ADDENDUM NO. 1

April 12, 2021

HANOVER CENTRAL HIGH SCHOOL ADDITIONS AND RENOVATIONS Cedar Lake, IN 46303

[illegible]

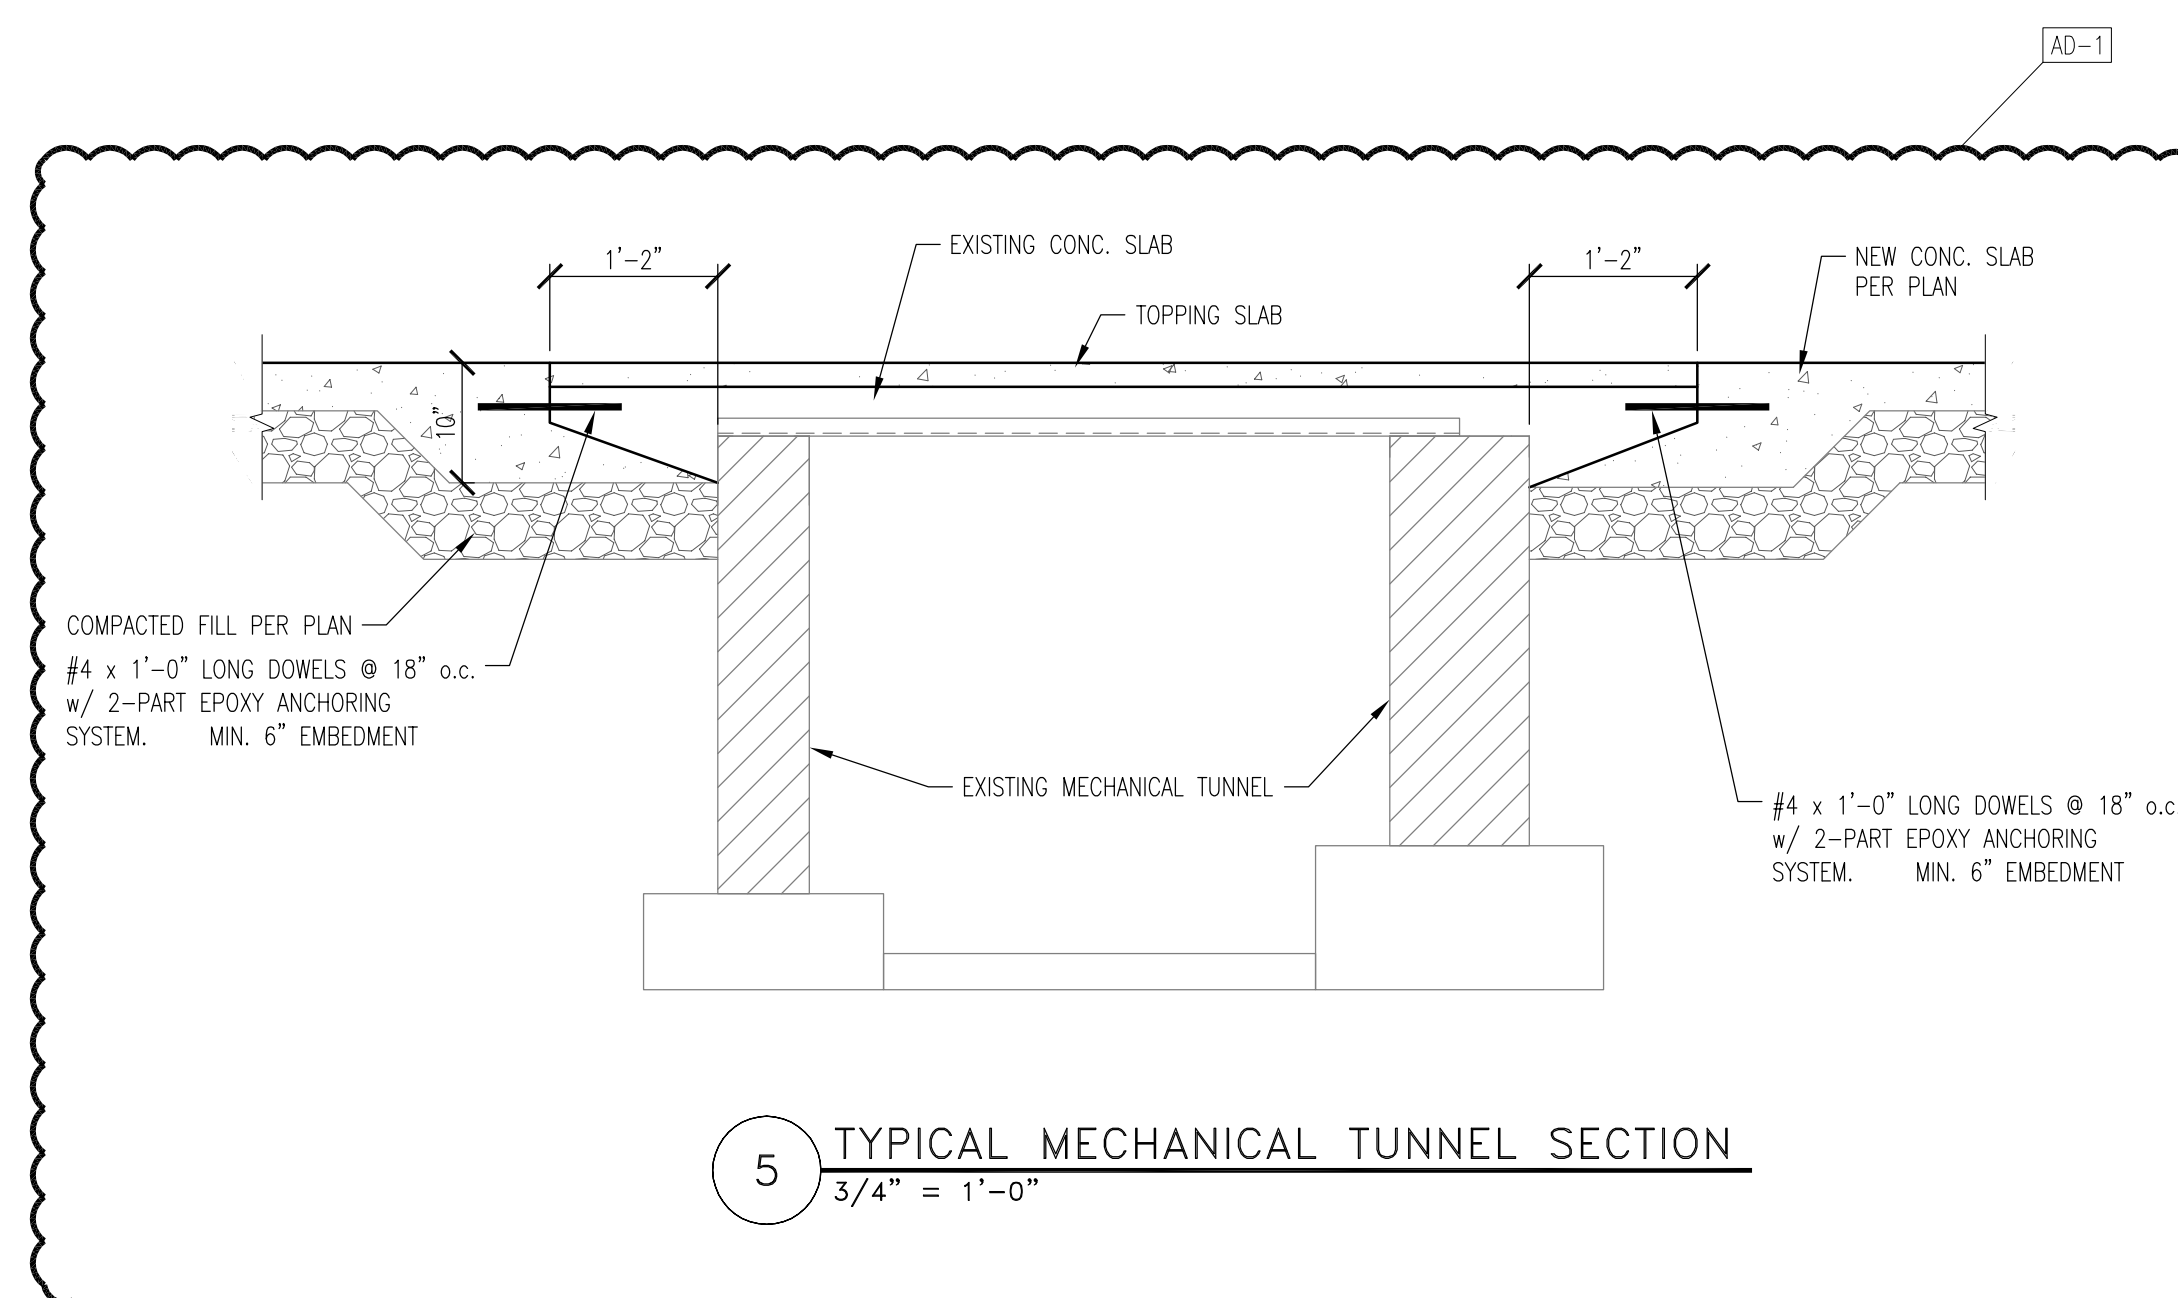
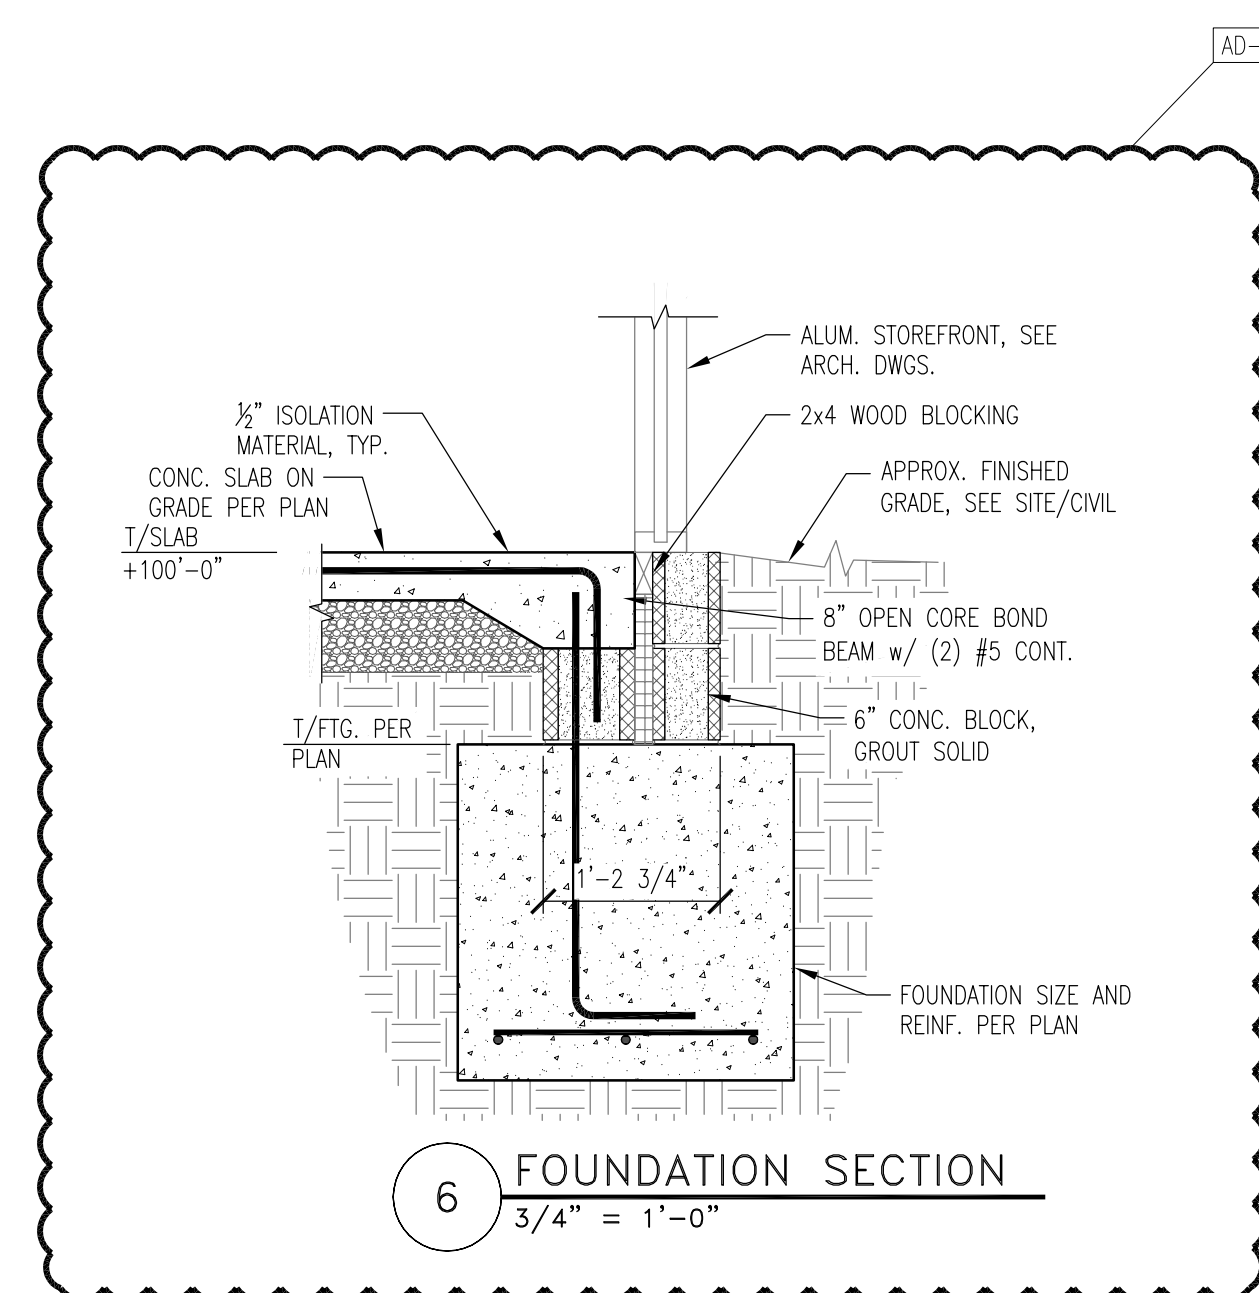
- A. Refer to revised full size drawing, included in this Addendum, for the following revisions:
 - 1. Section 5/S-401 was added.
 - 2. Section 6/S-401 was added.
 - 3. Section 7/S-401 was added.

4
A-503

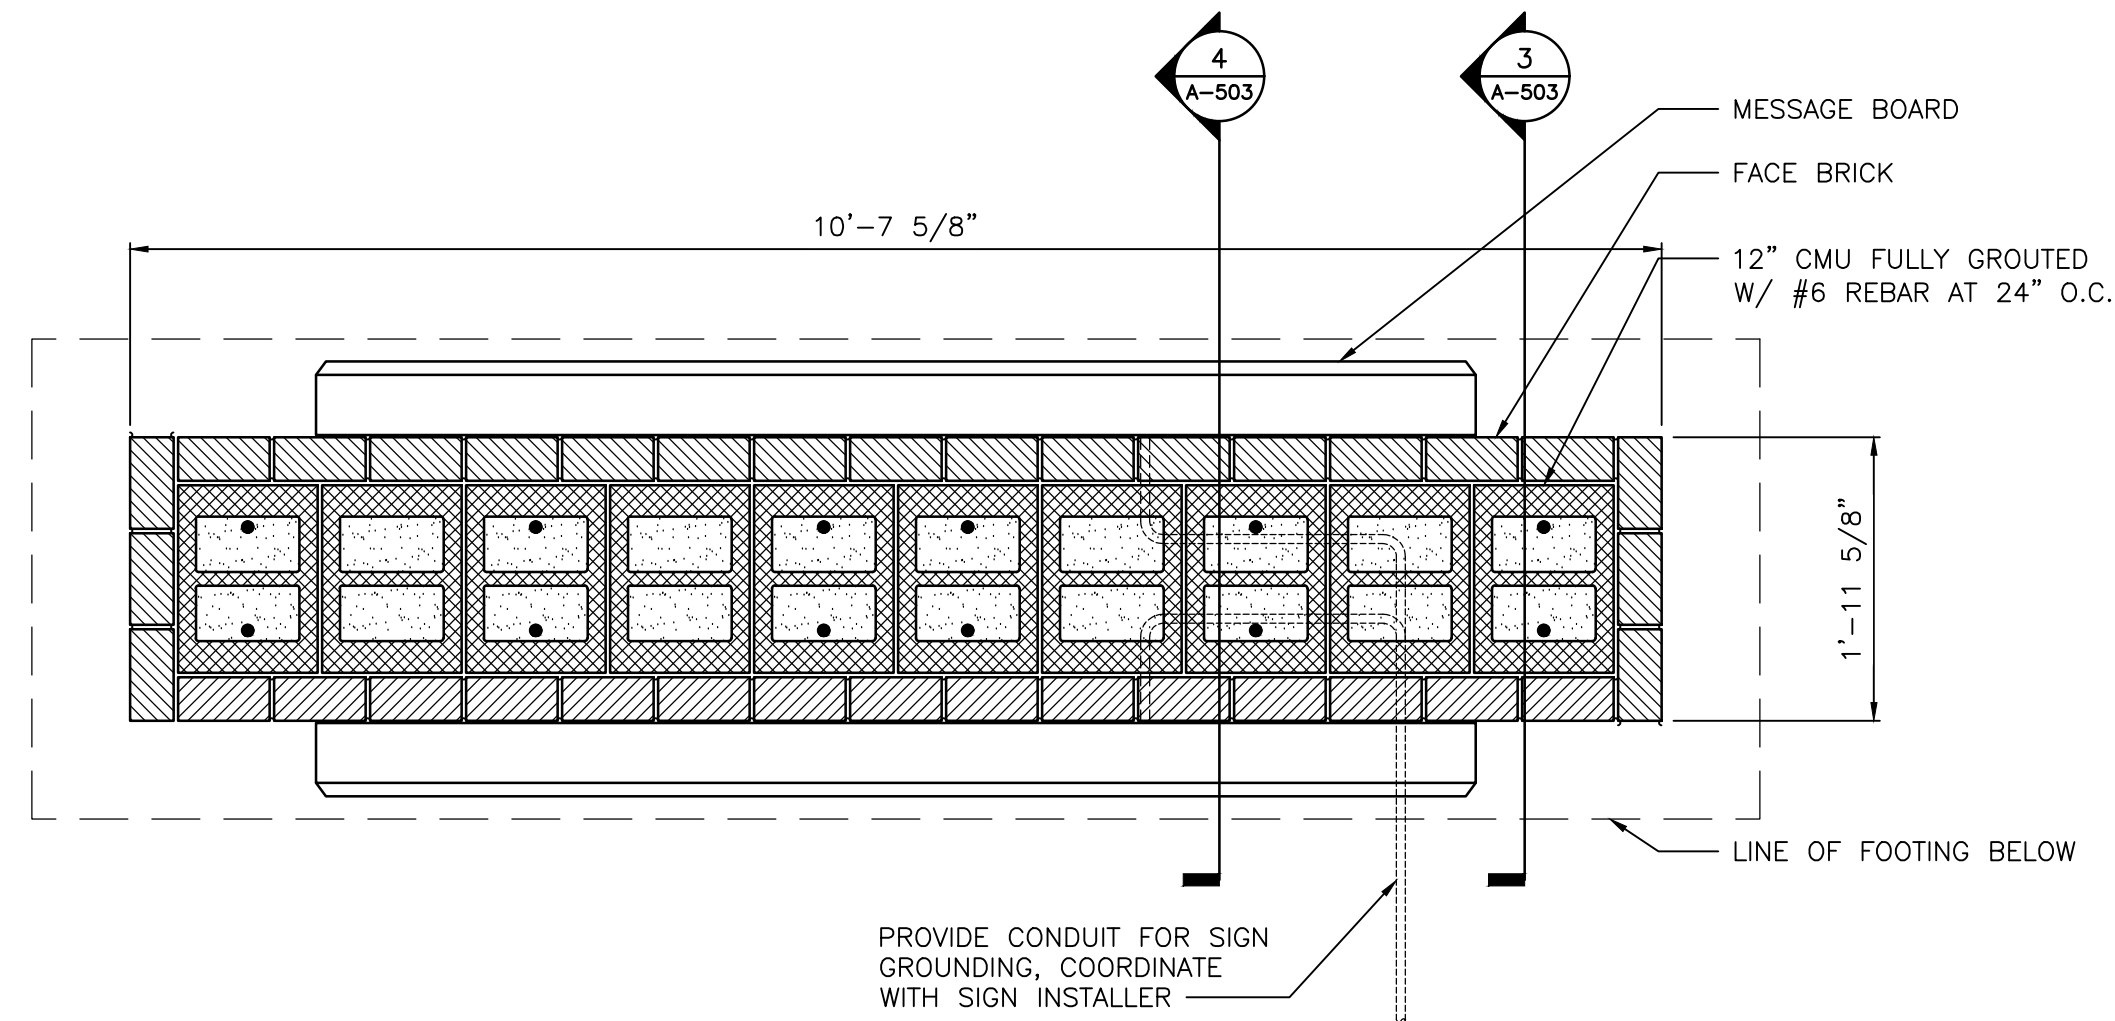
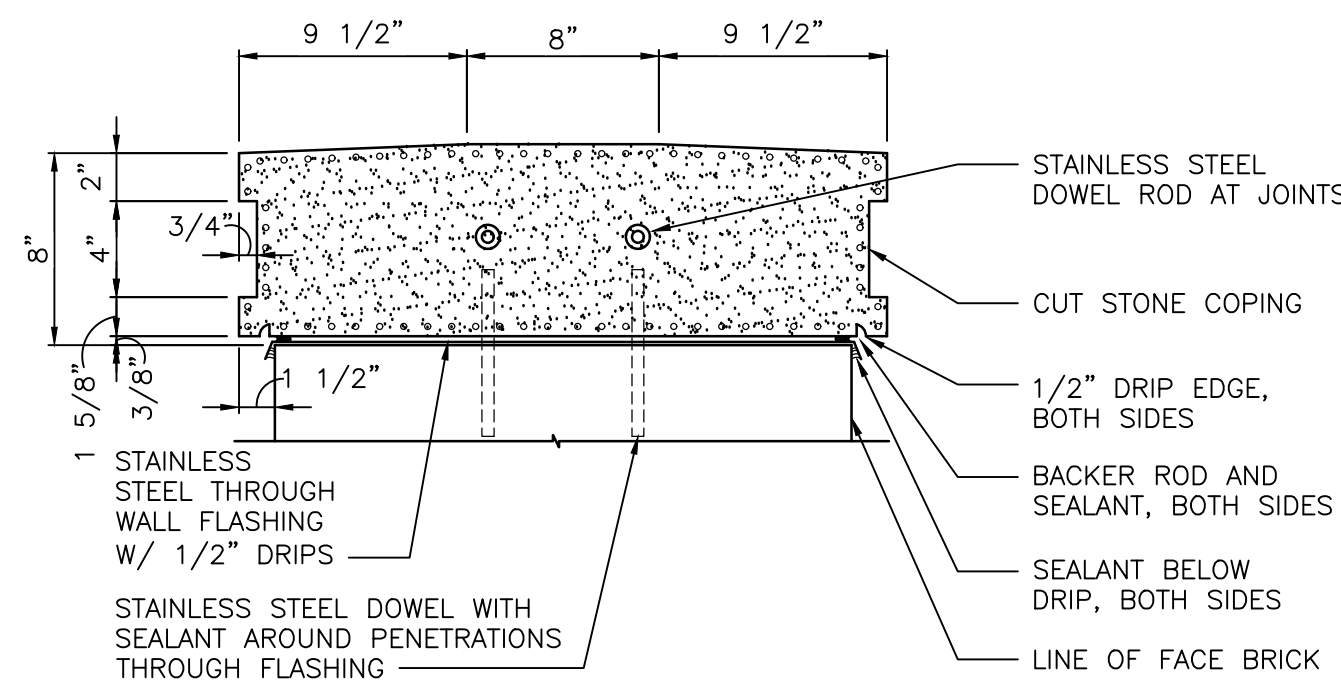
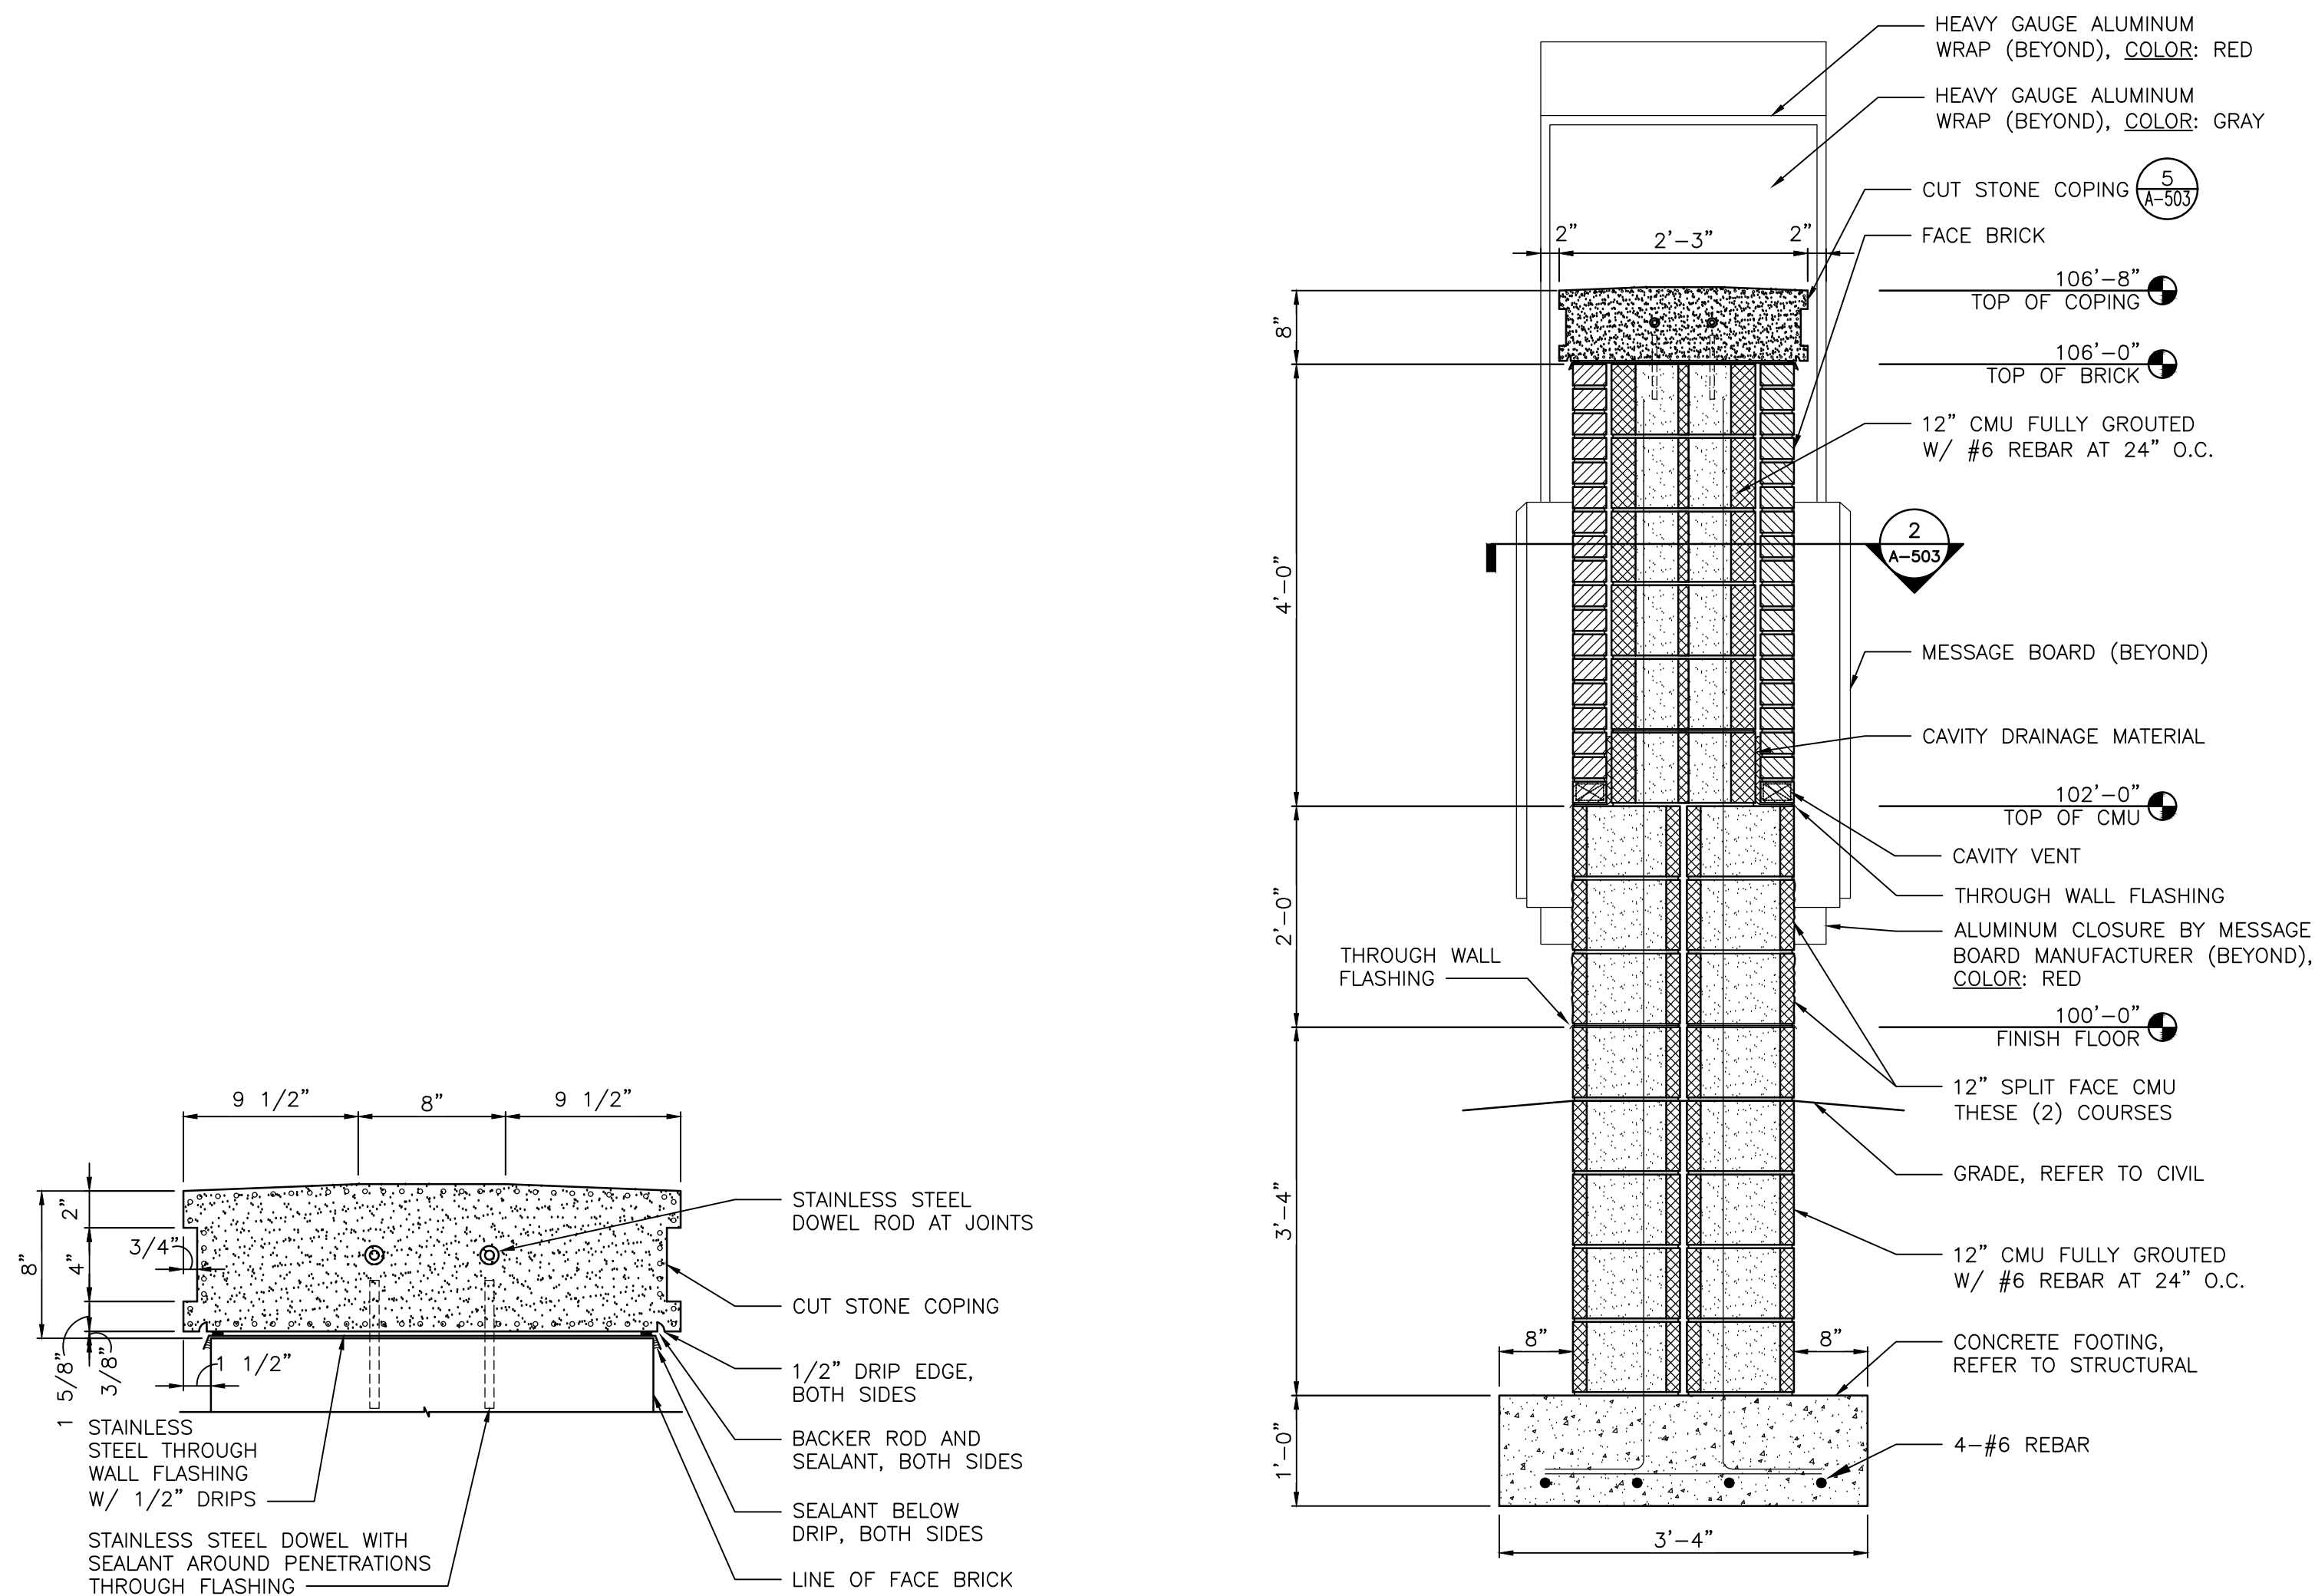
- A. Add new Sheet A-503, included in this Addendum, to the Project Documents.
